**Energy, Minerals and Natural Resources Department
Mining and Minerals Division**

July 27, 2021

RE: Clarification of Agencies Position Regarding Closure Plan Submittal, St Anthony Mine

Figure 2.5 – Alternative E: Pit Closure II

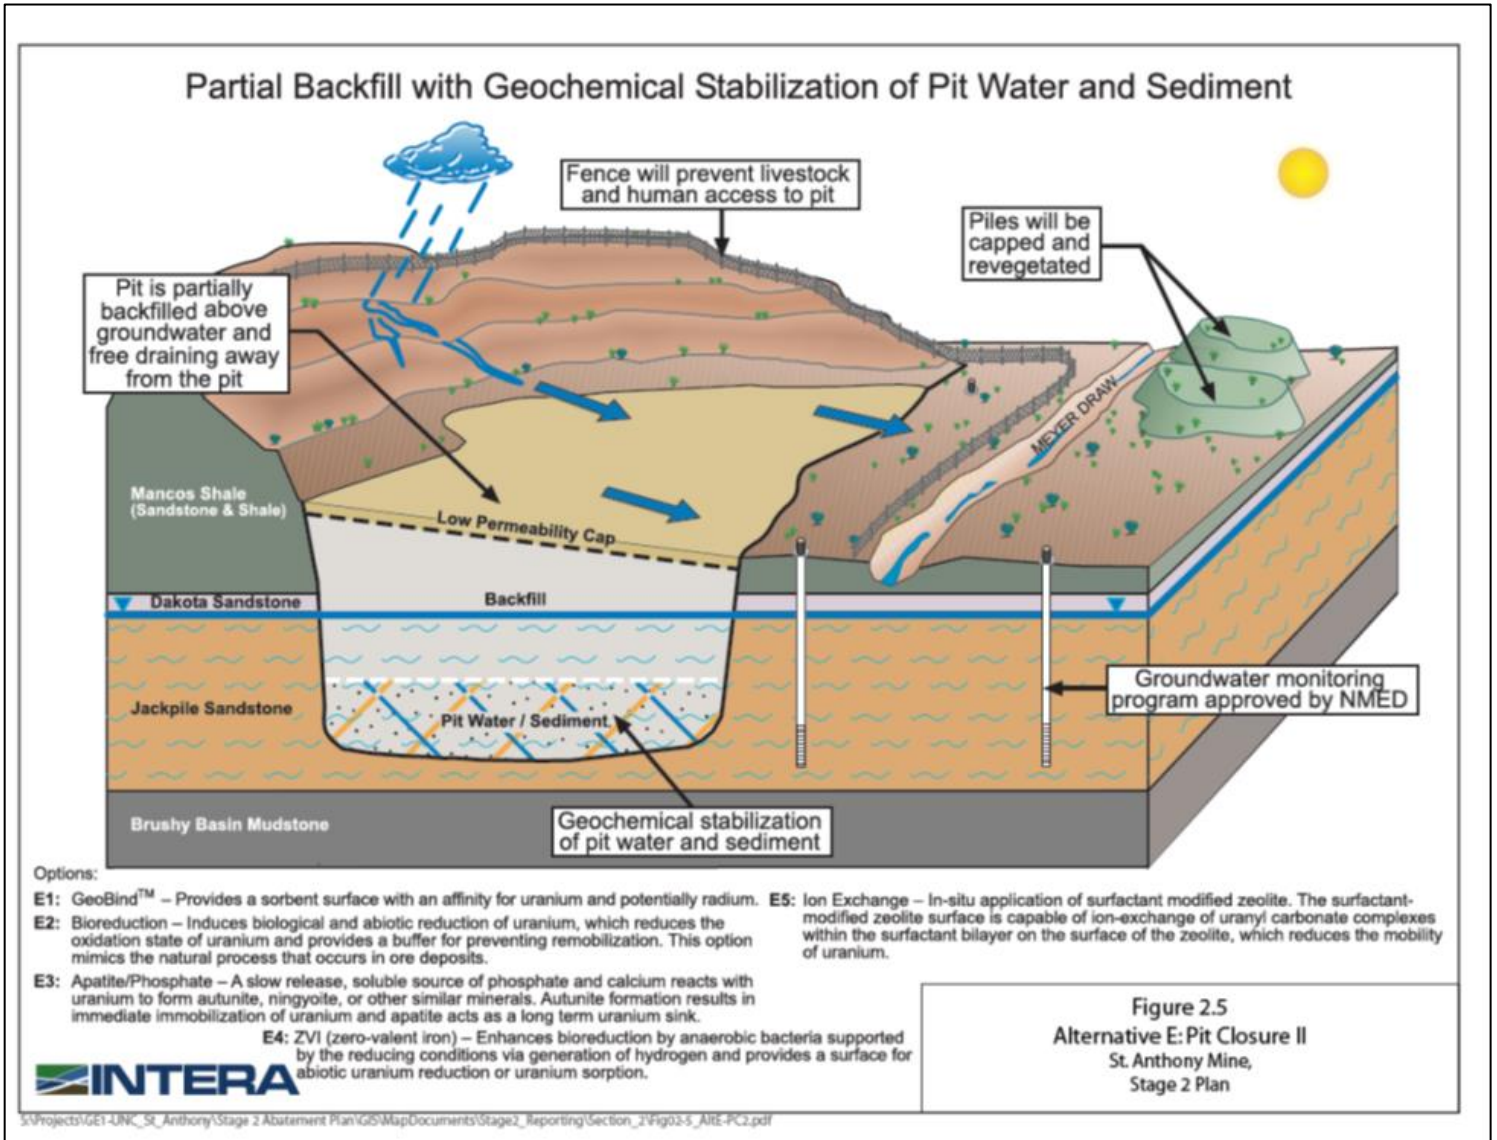
Accounts Analysis (MAA) process that the partial backfill proposed and approved by NMED would result in a condition whereby surface water runoff from the reclaimed surface of Pit 1 would flow away from the pit. The image labeled “Figure 2.5” in this letter is from the approved Stage 2 Abatement Plan and depicts a pit backfill to a level that will result in surface flow off the reclaimed surface and away from the pit. There is also a text box stating, “Pit is partially backfilled above groundwater and free draining away from pit.” Subsequent documents including the May 7, 2015 NMED approval of the Stage 2 Abatement Plan and the Water Quality Control Commission (WQCC) approved Alternative Abatement Standards Proposed Findings of Fact, Conclusions of Law, and Final Order dated September 29, 2017 include statements regarding “positive drainage away from the backfilled pit” and “positive drainage” respectively. UNC refused to provide NMED with an engineering design as a component of the Stage 2 Abatement Plan, arguing that the engineering design would be provided through the Mining Act process. Instead of pressing UNC for an engineering design, in a good faith effort, the Agencies relied on the figures presented by UNC during the MAA process and reproduced in the Stage 2 Abatement Plan.

Figure 3.1 Pit 1 Backfill Surface Contours

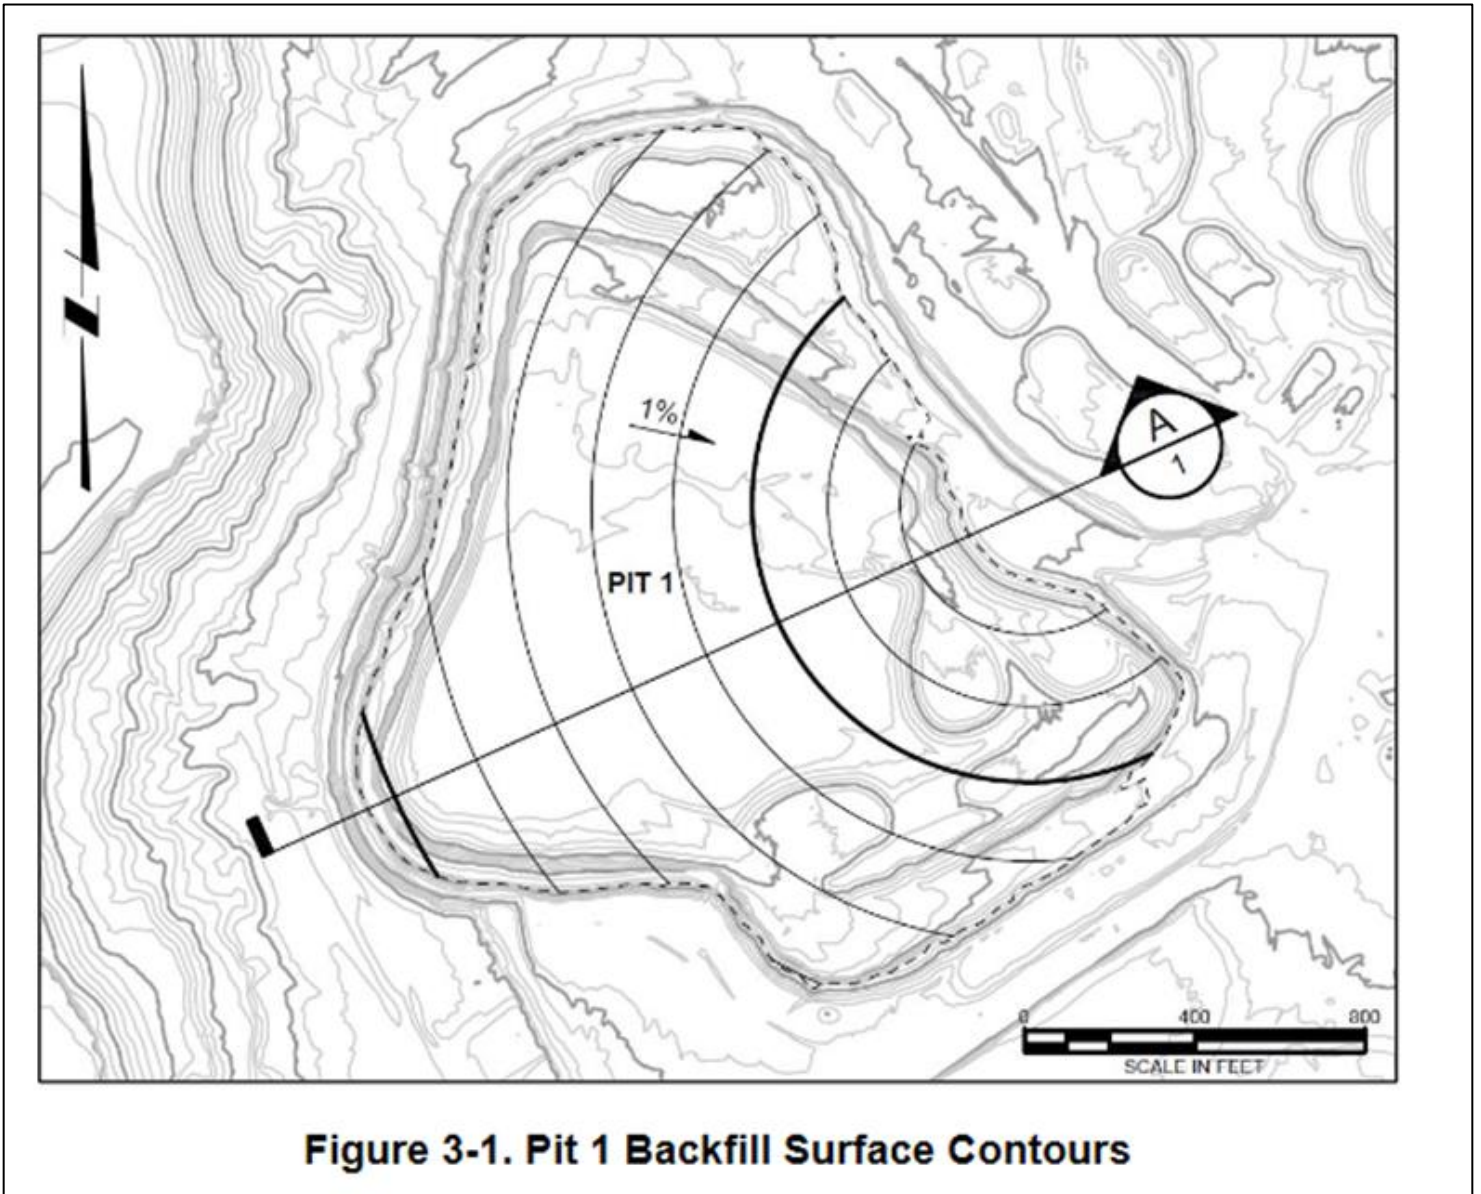
In UNC’s March 29, 2019 submittal to MMD titled “St. Anthony Mine Closeout Plan” the proposed engineering design for Pit 1 was not consistent with the figures previously provided to the Agencies and other participants in the MAA process and the Stage 2 Abatement Plan. The proposed engineering design that UNC submitted in the St. Anthony Mine Closeout Plan would not result in surface water “free draining away from the pit” or “positive drainage.” Instead, the proposed engineering design will result in a closed basin with surface water being contained in a topographic low within the pit boundary. This is shown in figures in this letter taken from the St. Anthony Mine Closeout Plan labeled “Figure 3.1” and “Figure 3.2.”

NMED provided comments to UNC on the St. Anthony Mine Closeout Plan in a letter dated August 16, 2019. In that letter, NMED stated that the St. Anthony Mine Closeout Plan pit backfill proposal did not meet the requirements of the approved Stage 2 Abatement Plan, and also mentioned the concern raised by UNC regarding the potentiometric surface of the Jackpile Sandstone following backfill. It was the Agencies’ expectation that UNC would provide a closeout plan that met the requirements of the Stage 2 Abatement Plan for positive drainage, and that the plan would also address the concerns regarding the Jackpile Sandstone potentiometric surface following one of the paths that UNC had discussed in conversation with the Agencies, as summarized above.
